AERODROMES PANEL (AP)

VISUAL AIDS WORKING GROUP (VAWG)

Agenda Item 6: Use of light emitting diode (LED) technology in visual aids

TAXIWAY CENTRELINE PERFORMANCE AND LINE LIGHTING

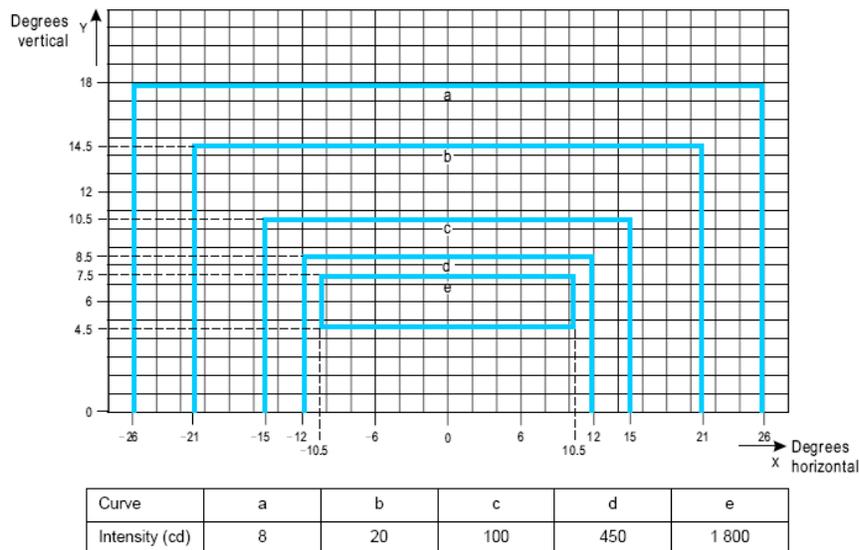
But is ICAO saying here that "ground movements at a certain speed in very low visibilities or in bright daytime conditions" cannot be accomplished with the lights presented in Figures A2-12 to A2-14?? To an extent, that would seem to be the case. If the lights of figures A2-12 to A2-14 are specified for use in RVR less than 350, what is the justification to suggest that they cannot be

used at "very low visibilities". Why is it now necessary that a 9-fold increase of intensity be provided?? Just because it is an "advanced surface movement guidance and control system", how does that change the usability of lights which are already stated in 5.3.16.8 as useable for less than 350m RVR??

There may be justification in this for "bright daytime conditions". But presently specified lights of article 5.3.16.8 are being used during daytime. So again there would seem to be a contradiction.

And further, why are the figures A2-17 to A2-19 different in presentation than those of A2-12 to A2-16?? Does the advent of an advanced surface movement guidance and control system change the manner in which lights are seen by the pilot?? Figures A2-17 and A2-18 have the light unit setting at 6 degrees vertical. This may be necessary for closer view of the lights. Yet in Figure A2-19 the beam centre is brought down to 4.25 degrees vertical which is less than that of the 4.5 degrees in Figure A2-12/13 and the 5.5 degrees of Figure A2-14.

It is not the purpose of this paper to suggest that the figures of Appendix 2 are inadequate. Our purpose is to emphasize the need for a description of the underlying photometric criteria. If this rationale is lacking for figures A2-12 to A2-16, it is even more so the case for figures A2-17 to A2-19.

3.6 It is therefore proposed that the whole of taxiway centreline lighting specification be revisited in order to identify the rationale or performance criteria which underlies the present photometric diagrams in Appendix 2.
